## Land and Environment Court New South Wales

<b>Medium Neutral Citation:</b>	<b>Sell &amp; Parker Pty Ltd v Minister for Planning [2017] NSWLEC 1586</b>
<b>Hearing dates:</b>	Conciliation conference on 19 September & 17 October 2017
<b>Date of orders:</b>	19 October 2017
<b>Decision date:</b>	19 October 2017
<b>Jurisdiction:</b>	Class 1
<b>Before:</b>	Maston AC
<b>Decision:</b>	See (4) below
<b>Catchwords:</b>	DEVELOPMENT APPLICATION: conciliation conference; agreement between the parties; orders
<b>Legislation Cited:</b>	Land and Environment Court Act 1979
<b>Category:</b>	Principal judgment
<b>Parties:</b>	Sell and Parker Pty Ltd (ACN 000 101 315) (Applicant) Minister for Planning (Respondent)
<b>Representation:</b>	Mr J Johnson, Allens(Applicant) Ms L Sims, Department of Planning (Respondent)
<b>File Number(s):</b>	2017/126126
<b>Publication restriction:</b>	No

***Sell and Parker Pty Limited v Minister for Planning***

<b>Application No:</b>	SSD 5041
<b>Applicant:</b>	Sell and Parker Pty Ltd
<b>Consent Authority:</b>	Land and Environment Court of NSW
<b>Development:</b>	Increasing the processing capacity of the existing metal recycling facility, including reconfiguration and

**TITLE:** COMBINED SITE PLAN  
 FIRE HYDRANT & WATER CANON SYSTEMS

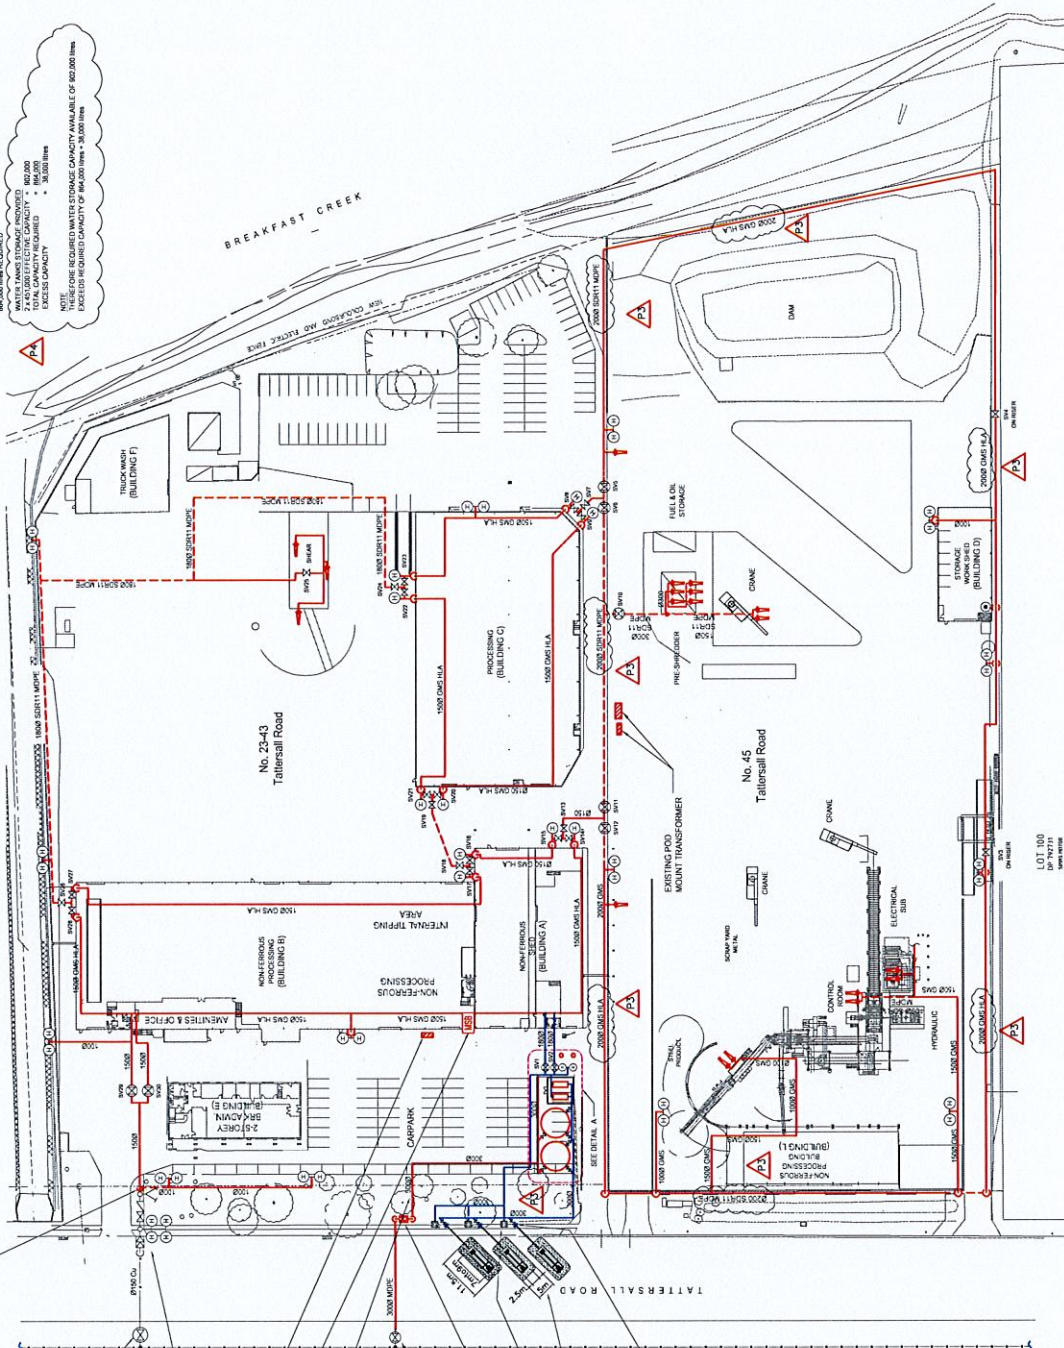
- (whichever is sooner), the Applicant must ensure that all fire safety measures required by the NCC for Buildings A, B, & C (as shown on drawing 14023-16-001-FH-01 Rev P4) have been installed and verified through a Fire Safety Audit in accordance with Australian Standard 4655 – Fire Safety Audits, to the satisfaction of FRNSW.
